Project Reference: 10064

Further to a request for further information made at a recent meeting with Coffs Harbour City Council, Health Infrastructure, Bonacci Group and the Project Manager we provide the following advice:

Figure 4 Proposed Development site catchment areas ultimately draining to pit H1 (proposed pervious and impervious proportion)

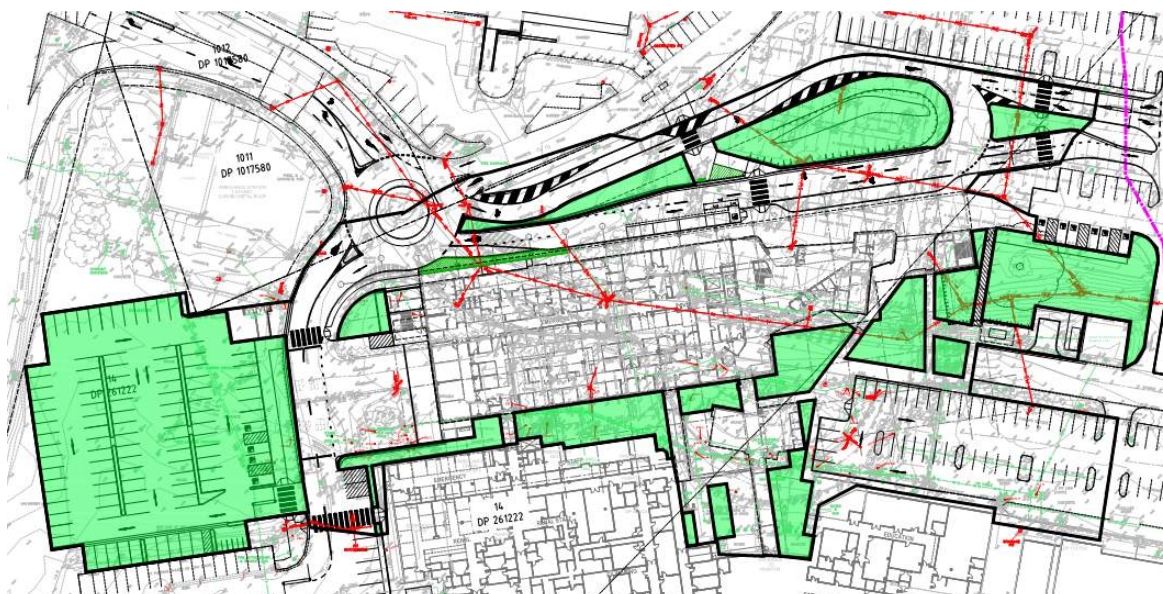
Item 3 Water Quantity

The proposed development has increased pervious area compared to the existing scenario. The development area ultimately draining to pit H1 (the existing pit in the depression adjacent to the large tree to the east of the proposed development) is approximately 1.775ha with nominally 33.2% and 35.3% pervious area in the existing and design case respectively. The catchment areas for the post-development and pre-development scenarios are shown in figures below.

Post development runoff would be largely the same as existing, with a slight reduction due to the slight increase in pervious area for the proposed scenario. A broad level DRAINS model shows that in the 1% AEP event using ARR2016 rainfall, post and pre development flows are 1.73m³/s and 1.74m³/s respectively, a reduction in runoff of approximately 10L/s. This is consistent for the minor storm events. The flows for minor and major storms are summarized in table below:
